# Economic and Social Council

## Report of the Working Party on Noise on its seventieth session

### Adopted amendments to UN Regulation No. 51 (based on ECE/TRANS/WP.29/GRBP/2019/13 and GRBP-70-26-Rev.1)

Annex 3 – Appendix, amend to read:

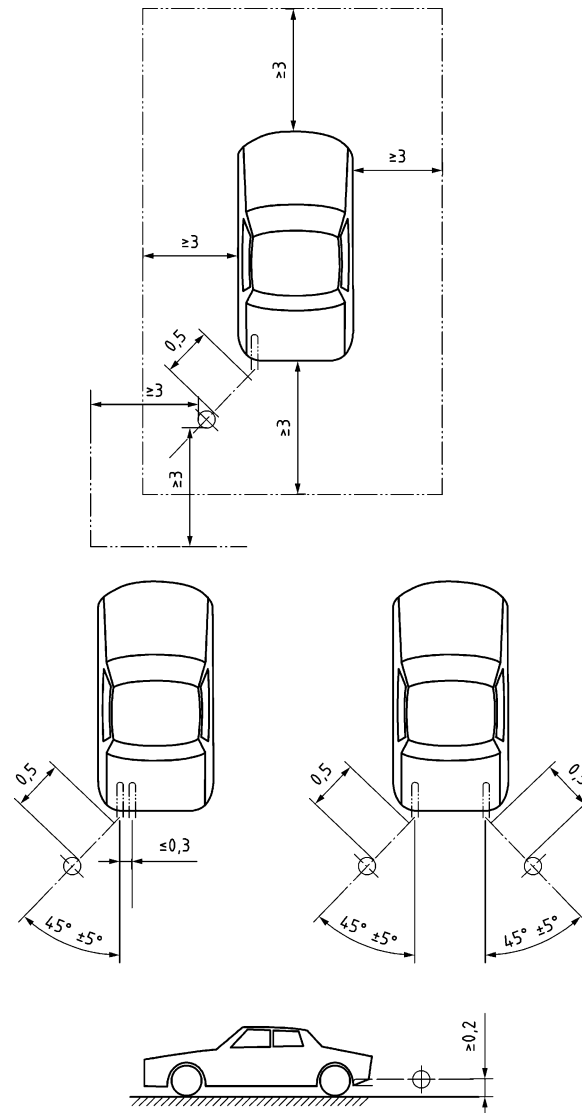
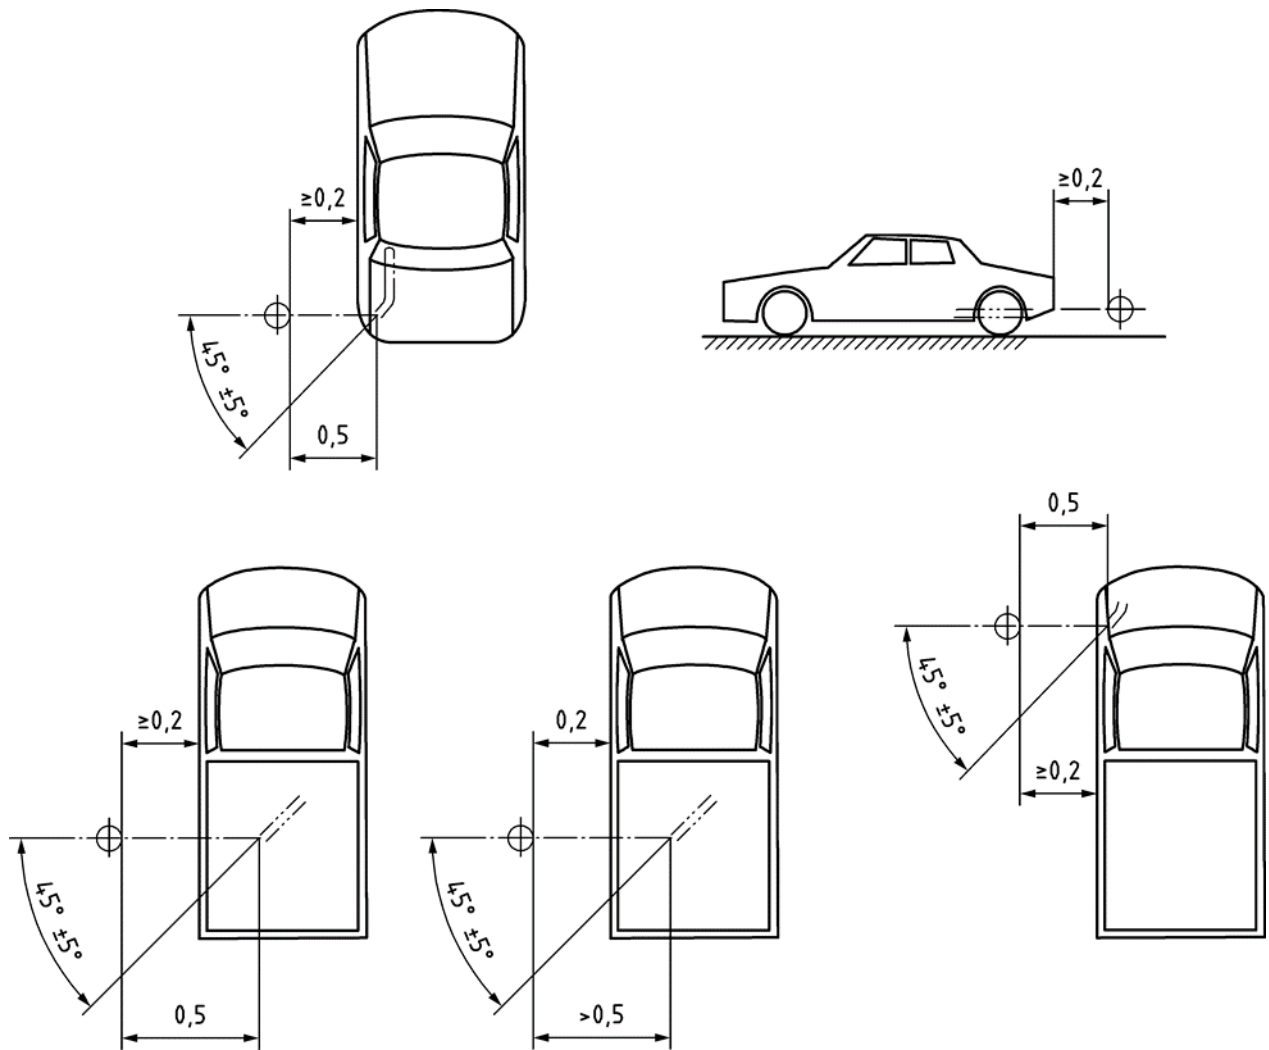
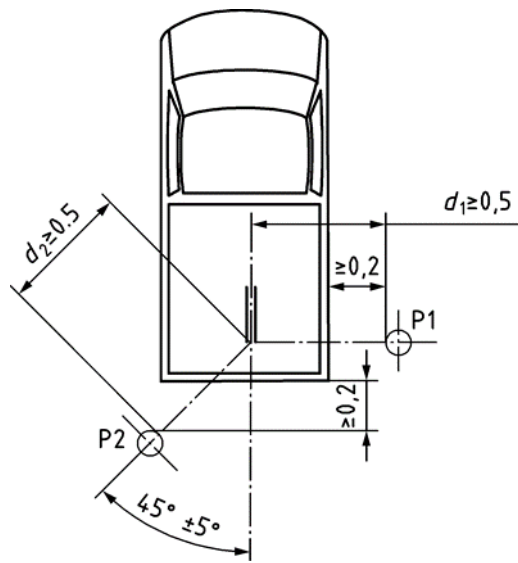
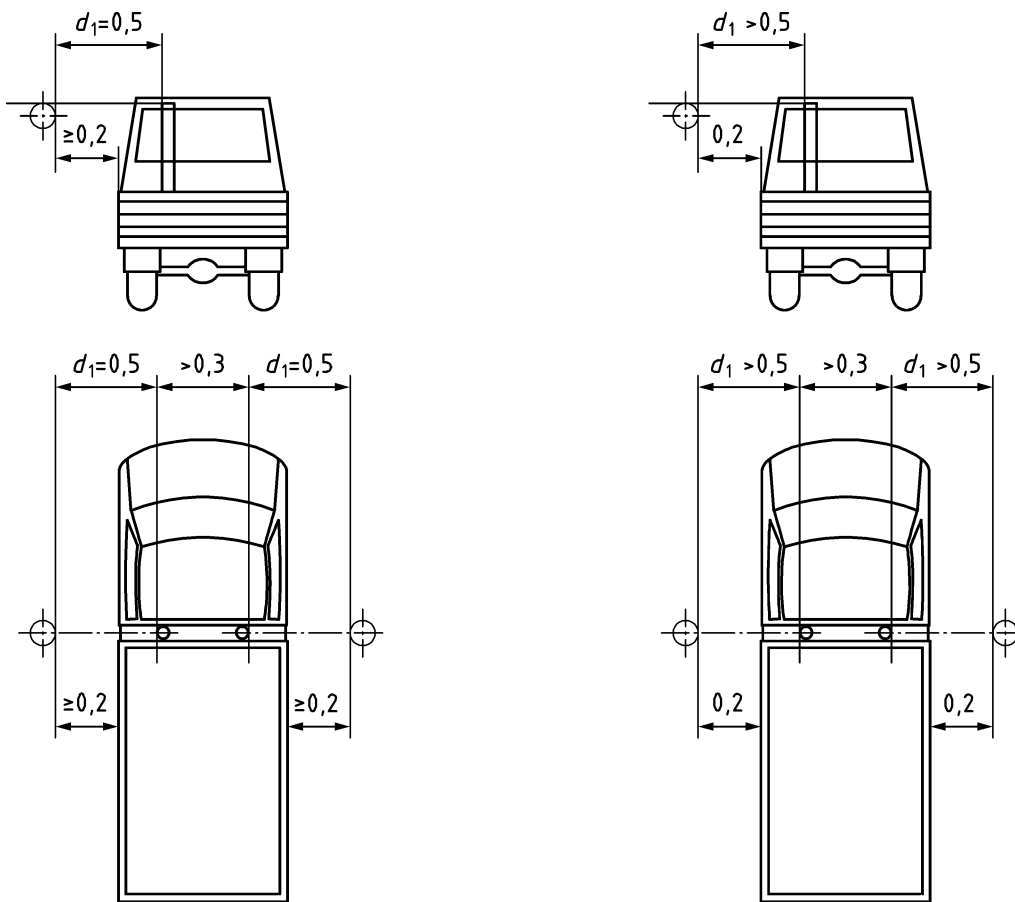
**For vehicles, where the reference point of the exhaust pipe is not accessible, or located under the vehicle body, as shown in Figure 3b and 3c in Annex 3, because of the presence of obstacles which form part of the vehicle (e.g. spare wheel, fuel tank, battery compartment), the microphone shall be located at least 0.2 m from the nearest obstacle, including the vehicle body, and shall not be located under the vehicle. Its axis of maximum sensitivity shall face the exhaust outlet from the position least concealed by the above mentioned obstacles. In case the distance from the exhaust outlet to the other side of the vehicle is larger than 0.2 m (Figures 3c and 3d in Annex 3), the following distances of  $d_1$  and  $d_2$  shall be chosen:**

**When several positions are possible, as shown in Figure 3c, the microphone position giving the lowest value of  $d_1$  or  $d_2$  shall be used."**

"Figure 4a

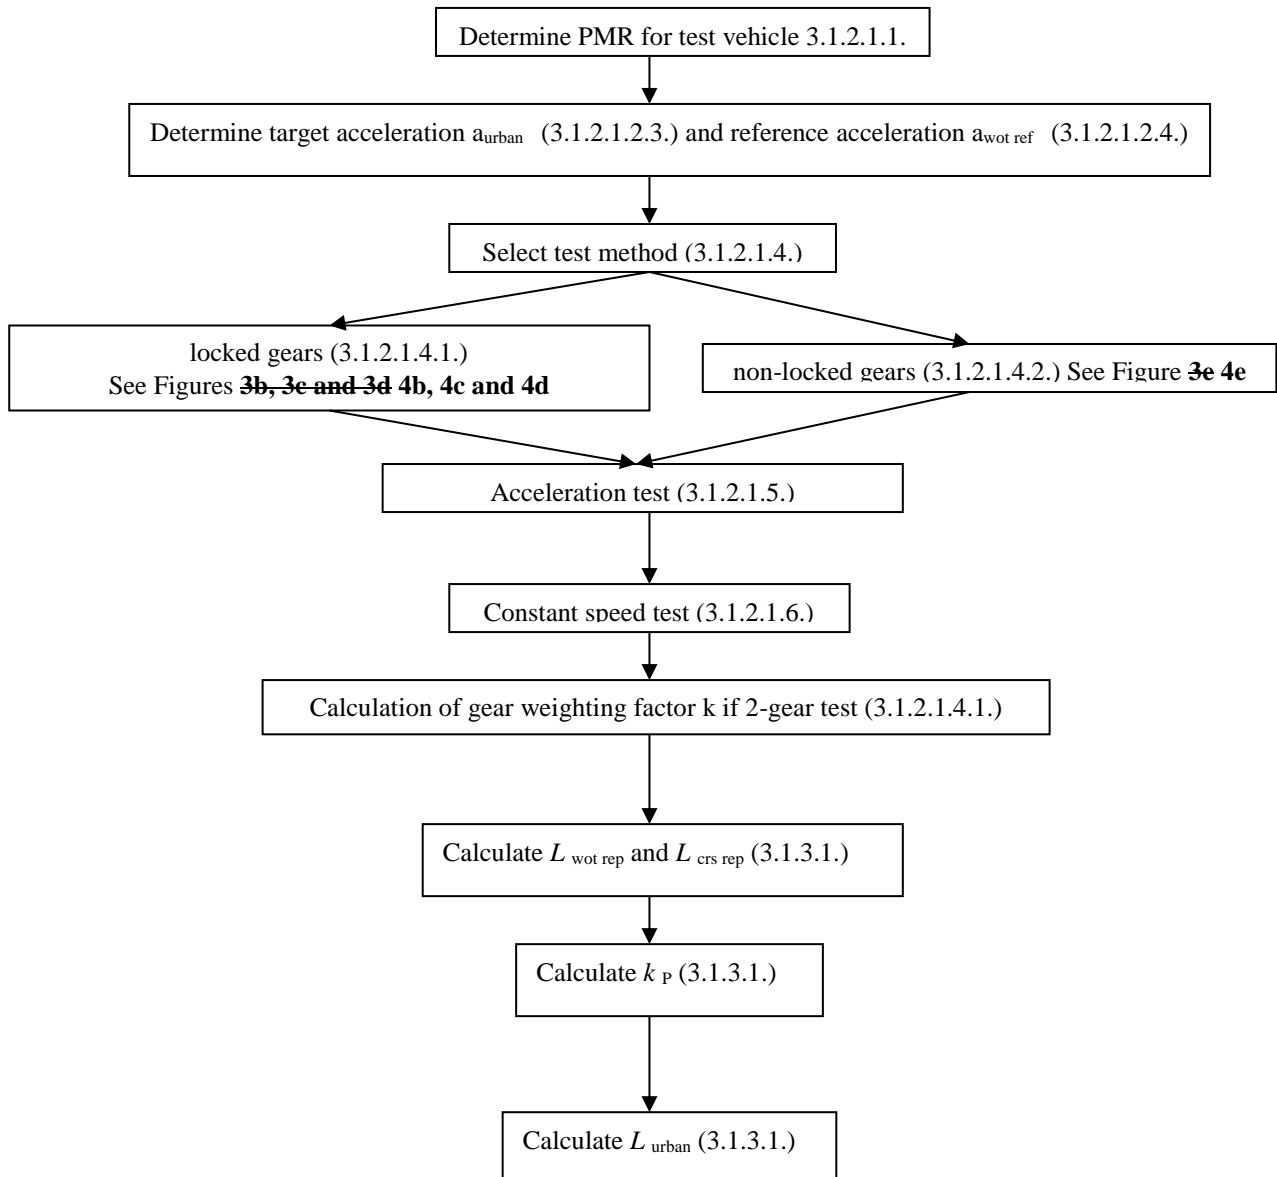
Figure 4a, amend to read

"Figure 4b

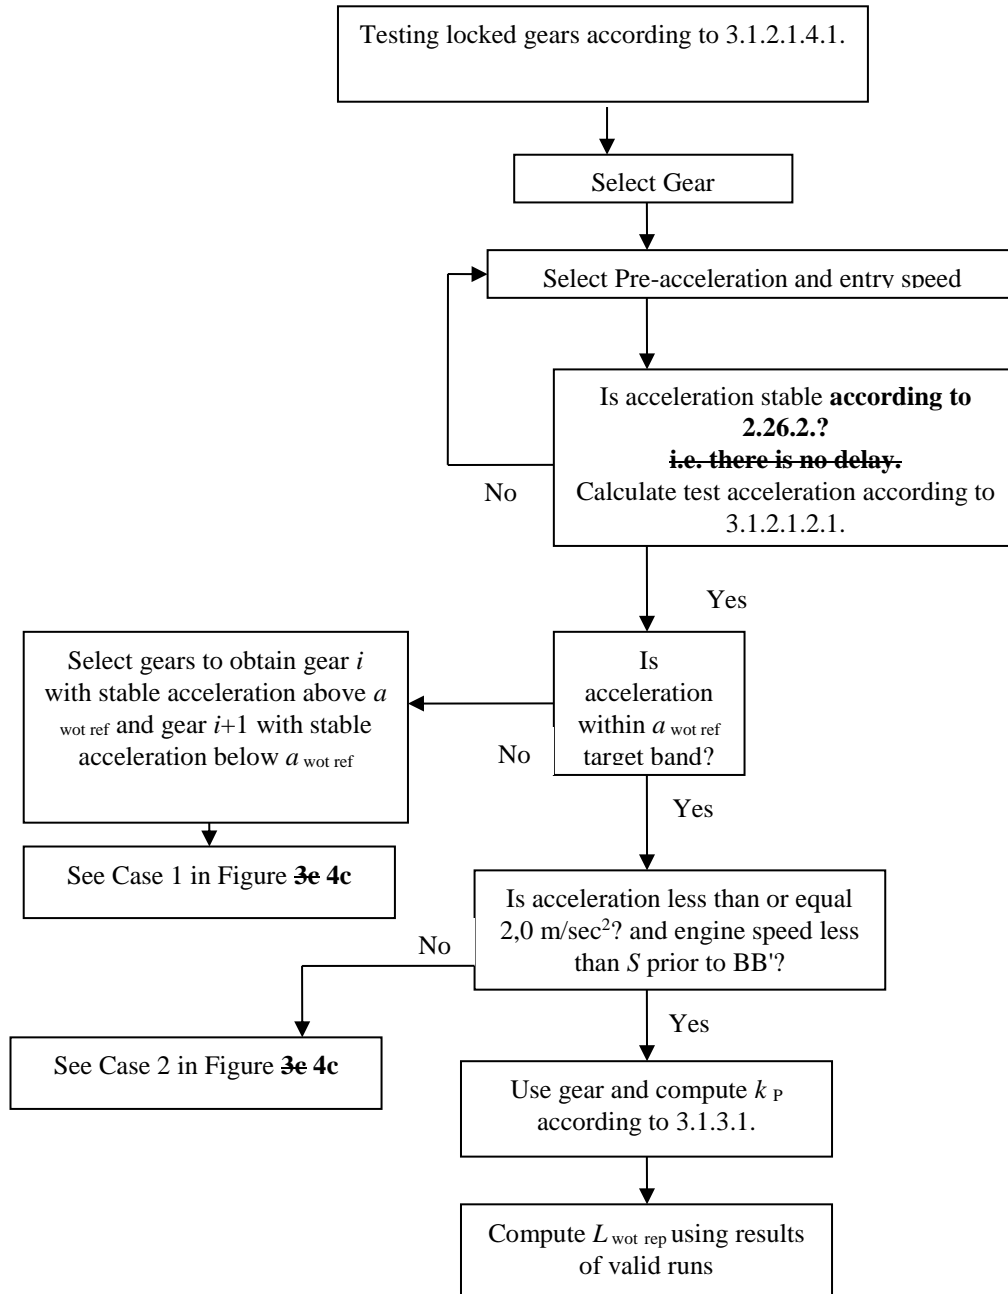
Figure 4b, amend to read:

**"Figure 6**  
**Flowchart for measurement and data processing of stationary sound according to**  
**paragraph 3.2.**

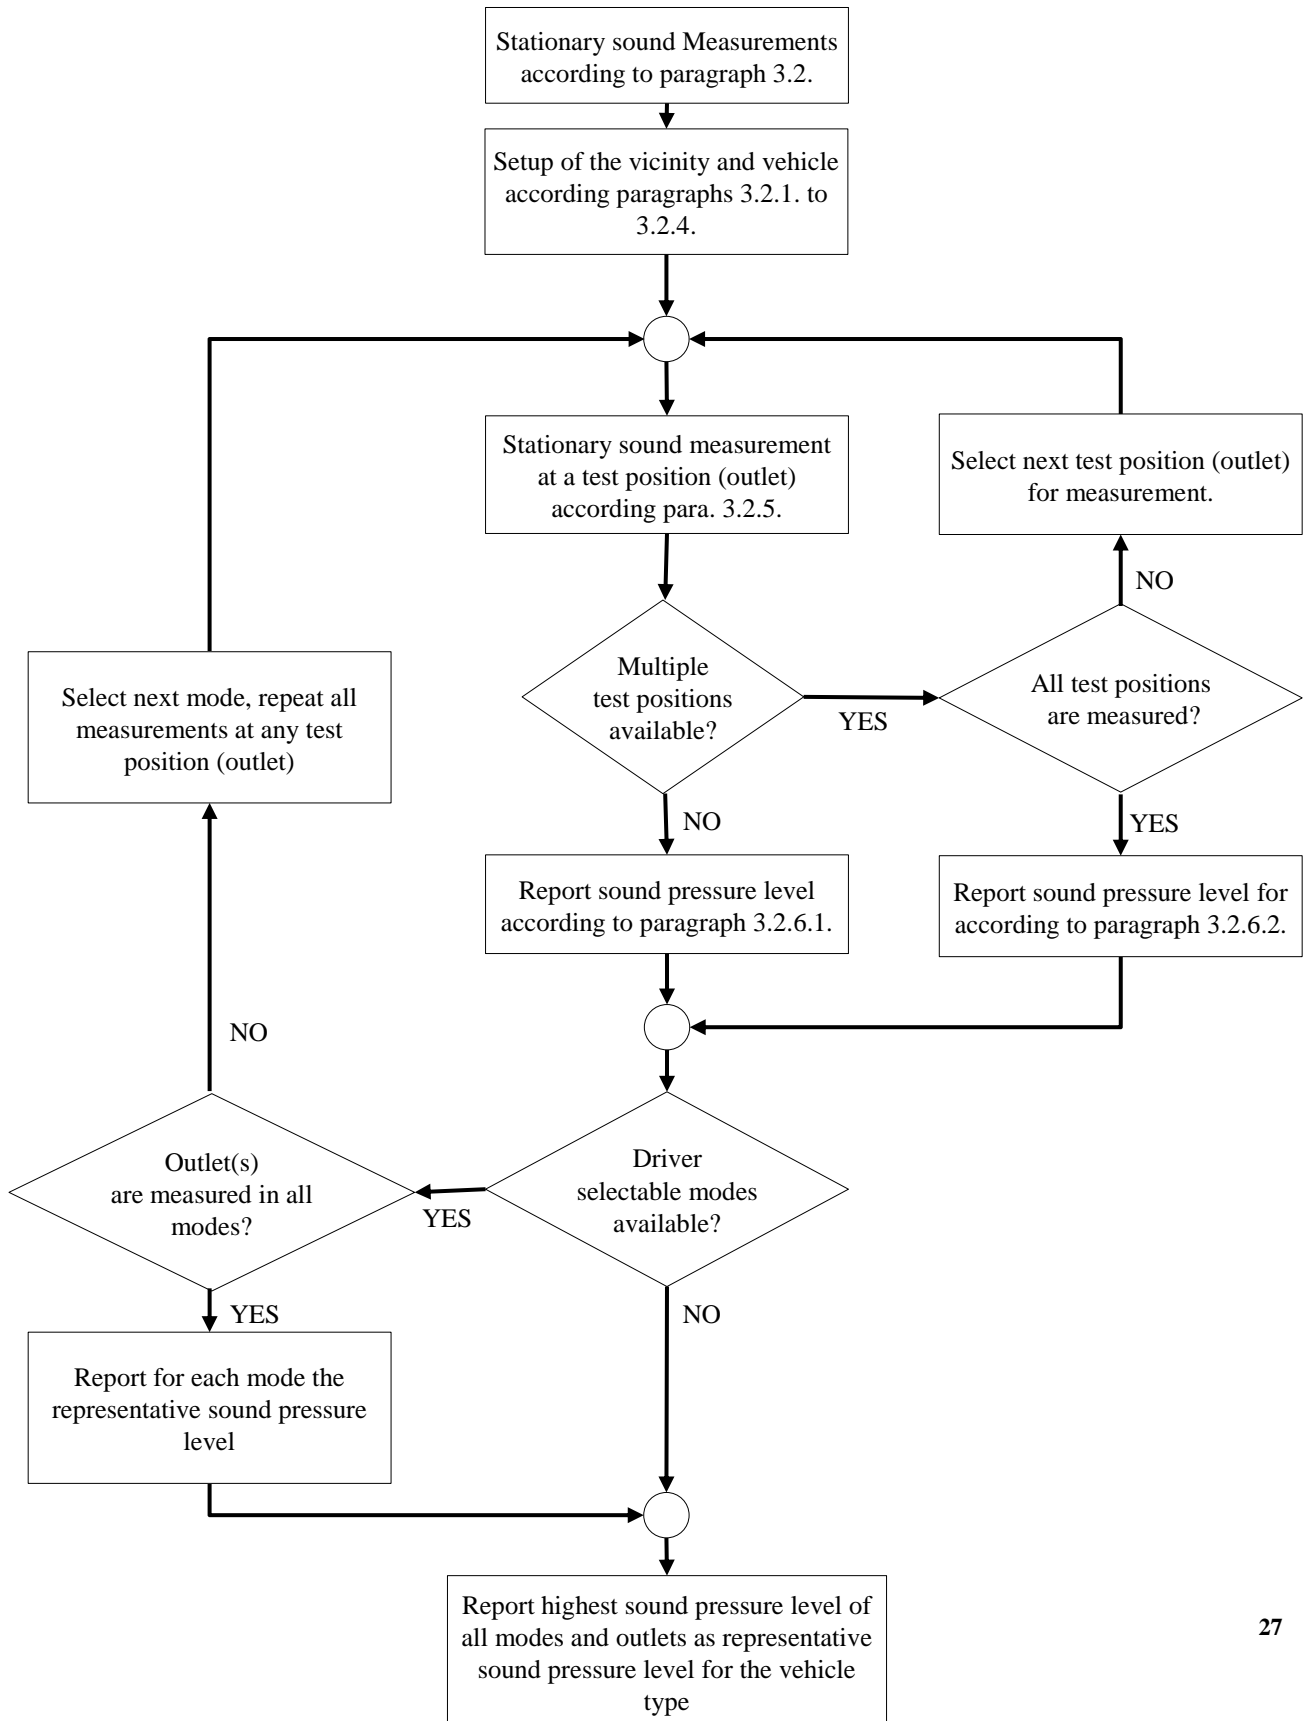
Add a new figure 6:
